EPA-CASAC-08-018

Subject: CASAC Ambient Air Monitoring & Methods (AAMM) Subcommittee  
Consultation on Approaches for Developing a Low-Volume Ambient Air  
Monitor for Lead in Total Suspended Particulate (Pb-TSP) Federal Reference  
Method (FRM) or Federal Equivalent Method (FEM)

**Figure 2.** Schematic of the Wide Range Aerosol Classifier (Burton and Lundgren, 1987) designed to sample total suspended particulate, as opposed to TSP which is imprecisely defined by an imprecisely specified high-volume sampler with a peaked roof inlet.

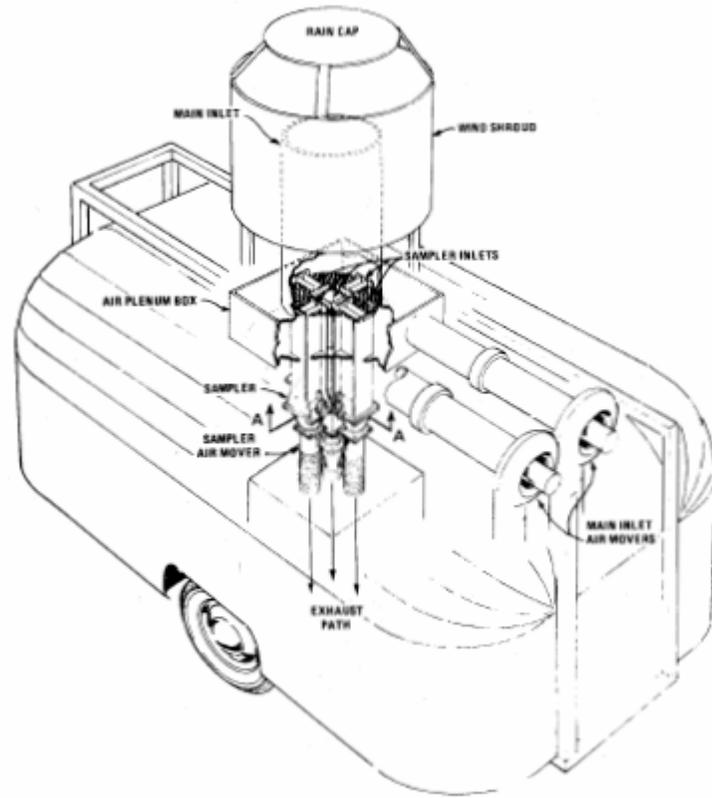
As noted several times before, TSP is defined by the dimensions and flow rates of the high-volume sampler, and even these vary substantially from sampler to sampler. We now have a better understanding of the inlets, flow controls, filter media, passive deposition, and wind speed/direction dependencies (McKee et al., 1971; Clements et al., 1972; Smith and Nelson, Jr., 1973; Chahal and Hunter, 1976; Benarie, 1977; Wedding et al., 1977; Blanchard and Romano, 1978; U.S.EPA, 1982; 1983; van der Meulen et al., 1984; Watson et al., 1989; Code of Federal Regulations, 2007a). A true TSP sampler (i.e., one that collects all of the suspended particles), would look like Figure 2, which is unlikely to be practical for most situations.

Figure 3 compares collocated measurements from TSP high-volume samples with medium-volume samples acquired with a sequential filter sampler (SFS; U.S.EPA, 1989). To emulate TSP, the SFS plenum and inlet were removed and each 47 mm filter holder was covered with a PVC end-cap to emulate the air velocity through the gap between the high-volume peaked roof

and sampler body (20 to 35 cm/sec, as noted above). Average efficiencies ranged from 66% to 106% with most of them being ~80%. This is the only test I am aware of that tried to emulate the peaked roof high-volume sampler inlet with another device.

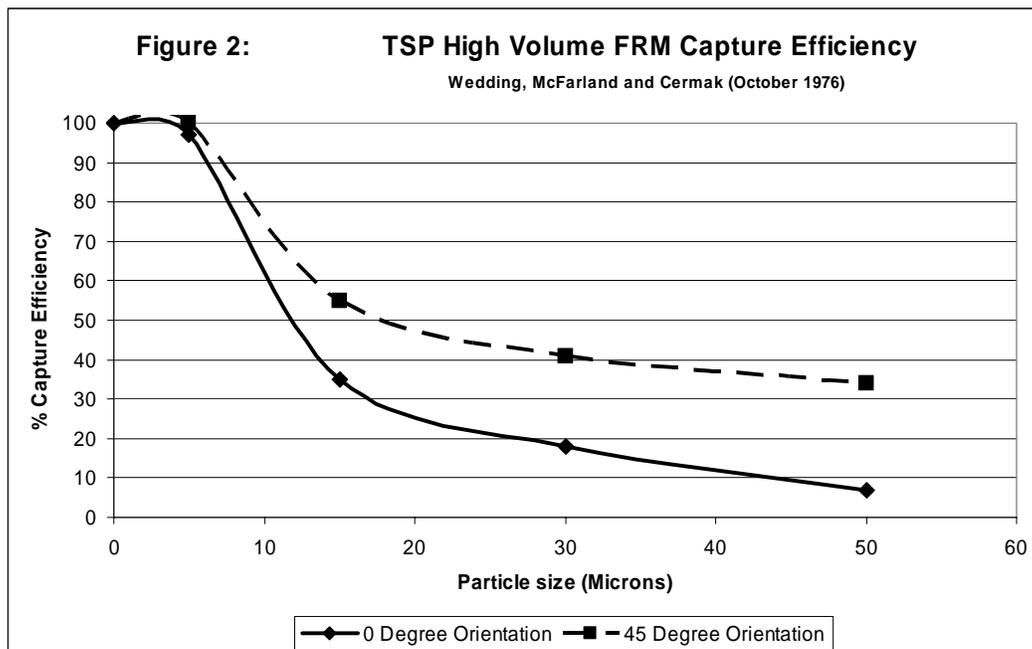
I realize that it is difficult for the health community to come to a consensus on the issue of determining the appropriate size of particles that must be captured in a future TSP measurement since many researchers investigate different exposure paths. In the absence of a consensus from the health community, collection efficiencies for the particle sizes required to be collected in a future TSP sampler should at a minimum be equal to or better than the existing TSP FRM. Wedding, McFarland and Cermak evaluated several samplers including the high volume TSP FRM sampler in a wind tunnel in October 1976. They found that the high volume TSP only collected 18% of 30 micron particles when the sampler roof was parallel to the wind direction and 41% of the 30 micron particles when the sampler roof was oriented 45° to the wind direction. Their data is presented in Figure 2 below:

Design specifications for a future low volume TSP inlet should require that the inlet capture efficiency curve be higher than the Hi-Volume sampler (oriented at 0°) curve (solid line). This will be a vast improvement over the existing FRM sampler since the resulting data will not be wind direction dependent and yet the magnitude of the data will still be as comparable as possible to existing TSP FRM datasets.
